# KUNZLER TERRACE MINE PROJECT

Final Environmental Impact Report  
SCH No. 2008042108

Prepared for  
Mendocino County  
Department of Planning and Building Services

May 2010

Attachments: Figure 1: Site Aerial Photograph and Vicinity with Domestic Water Well Locations  
Resume of Paul Wisniewski

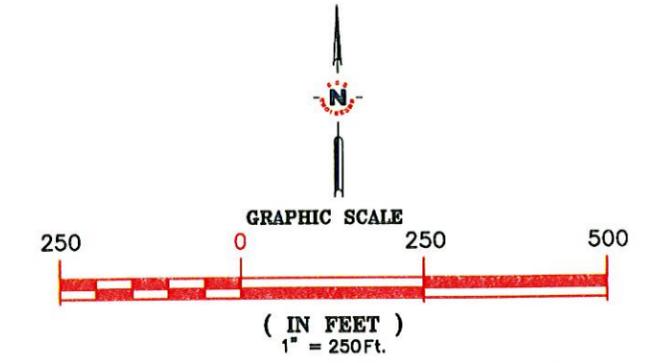
Page 9 of the DEIR notes that groundwater levels are estimated to fall by 3 feet due to the proposed mining operations. Groundwater wells used for domestic and industrial purposes immediately adjacent to the proposed mine site will likely be negatively impacted by this fall in groundwater levels (Figure 2, DEIR). Currently, there are (as previously mentioned) several wells located near the proposed mine site. One of these wells is in active production and may become a significant contributor to water resources of the Millview Water District. The wells are also required for current (e.g., agricultural, commercial) and future potential uses (e.g., various land developments that are planned or underway) of the adjacent properties. Over 200 acres of land rely on water from Well 6 and future development projects are relying heavily on this well to support future planned uses. Any fall in groundwater levels, decrease in production, or impacts to groundwater quality may have significant economic impact on the current and future use of adjacent property. The groundwater analysis contained in Appendix E does not appear to directly address the extent to which a hydraulic subsurface connection may exist

SITE LOCATION MAP

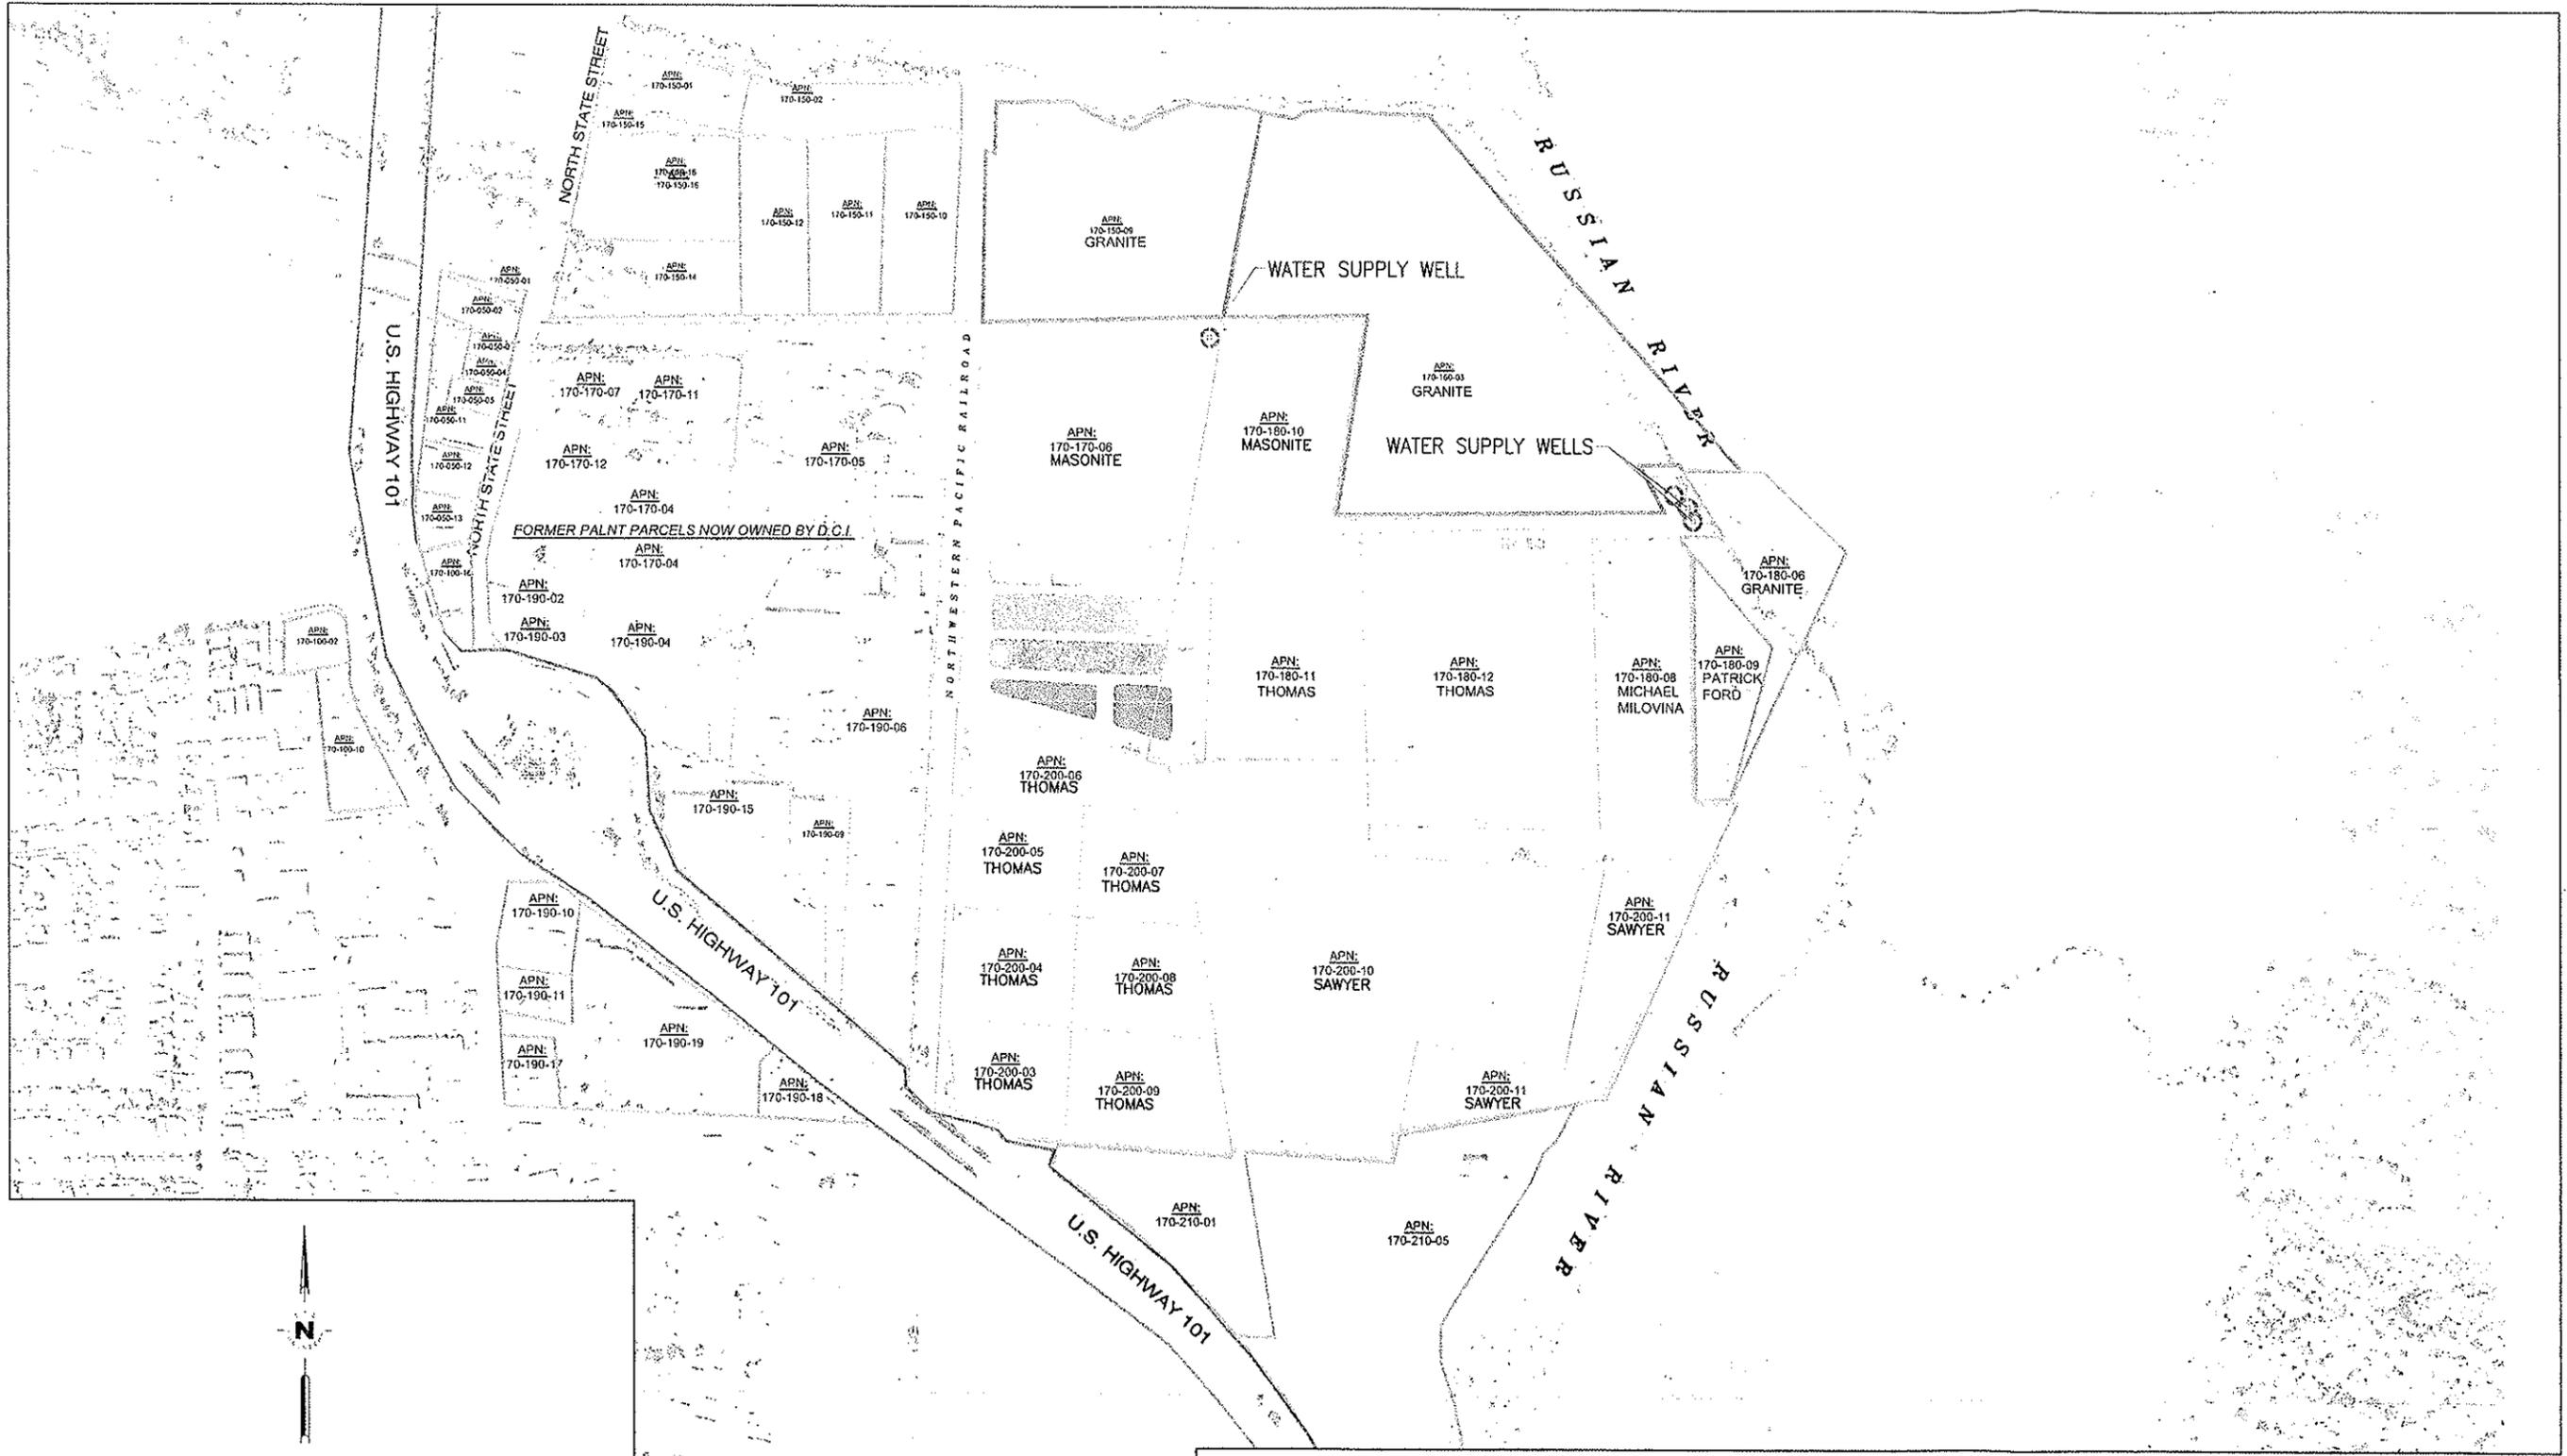
SCS understands that Granite has submitted an application to permit a mining operation known as the Kunzler Terrace Mine, which is located adjacent to the Russian River and Ackerman Creek near Ukiah in Mendocino County, California (Figure 1). Granite proposes to convert the current agricultural use (vineyards) to continuous open-pit mining of 67,000 to 167,000 cubic yards per year or 100,000 to 250,000 tons per year of "alluvial terrace sand and gravel" on 65.3 acres of land (Figure 2). The proposed open-pit mine will be completed in three phases with a total approximate mine life of 25 years. Equipment associated with the operations will consist of a drag-line, processing equipment, loaders, water trucks, haul trucks, and support vehicles. Mined material will be washed, screened and crushed on-site and then hauled to nearby existing facilities for further processing. Maximum proposed depth of the open-pit mine is 65 feet below
